## PRODUCT BULLETIN

**PB No.122**

**Subject: Upgraded VEE Engine Oil Filter System P-SPINON-8**

**Purpose:** Conversion of sock type filter system to spin-on filter system

**KIT PART NUMBER: P-SPINON-8**

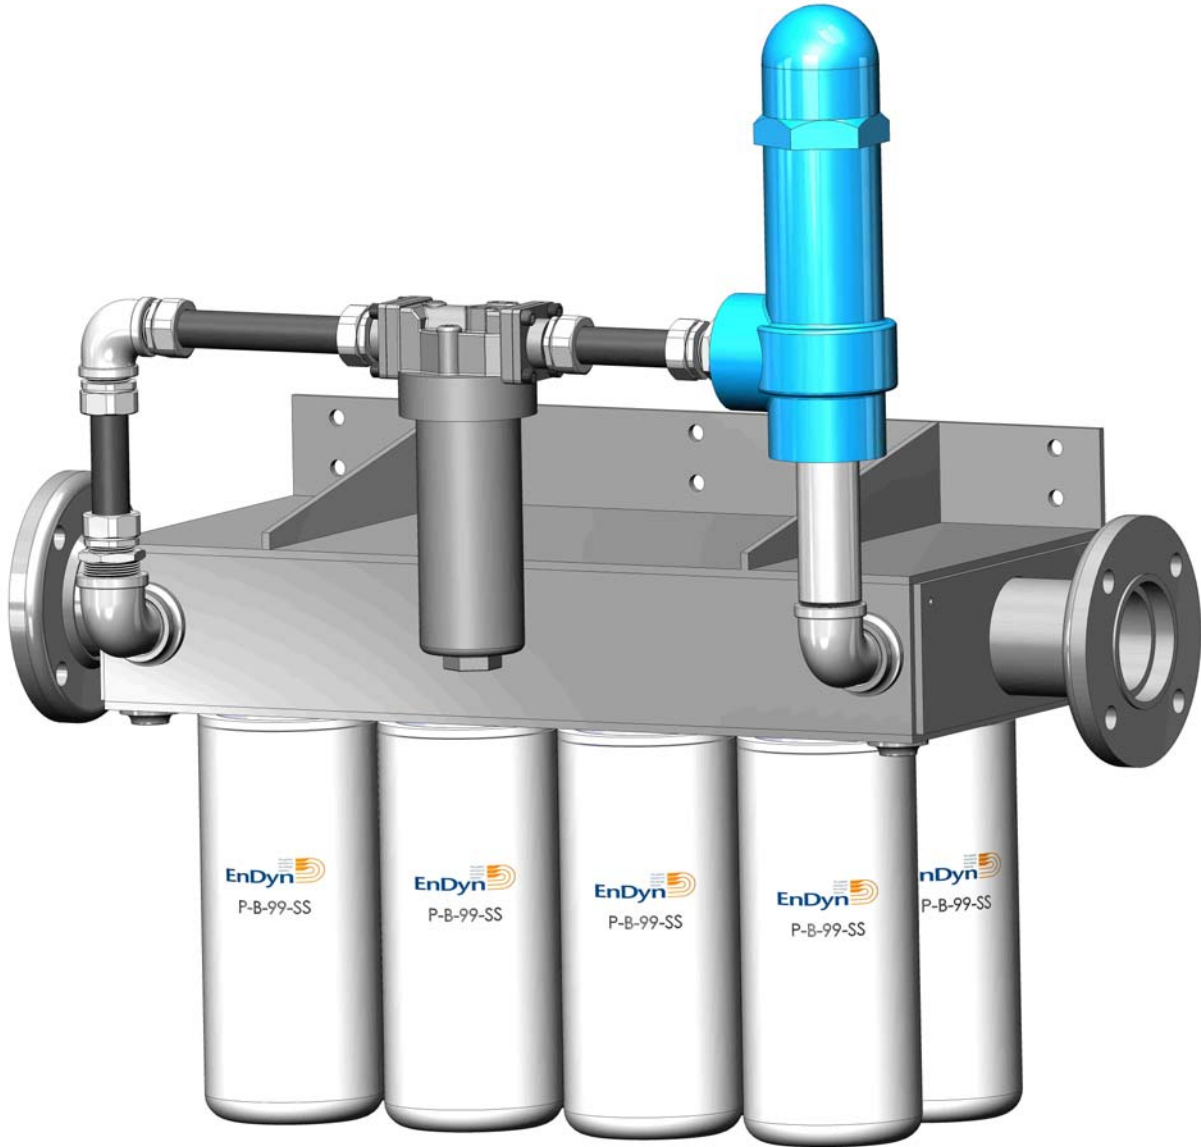
The original Superior oil filter system has basically remained the same for years, there have been many improvements in filter design since the sock filters were implemented.

With the modern trend of extended service between oil changes brought on by improvements in oil manufacturing technology and engine analysis programs, an improved filter system is now available to further improve reliability and simplify the maintenance of Superior VEE Engines. The spin on filter system will allow faster and cleaner filter changes reducing engine down time and clean-up associated with routine maintenance. An additional benefit of the spin-on filters can be seen in reduced contaminants in the oil due to a more uniform and efficient filter media found in modern filters.

A complete kit has been developed to make the conversion as simple as possible. However, there will be some field work involved to mount the filter system in the most convenient location for each individual unit. The filter kit consists of the following components:

- (1) 8 filter manifold
- (1) Bypass relief valve
- (1) Bypass screen filter
- (1) Differential pressure gauge
- (8) P-B-99-SS spin-on filters
- misc. hardware for bypass and screen filter installation
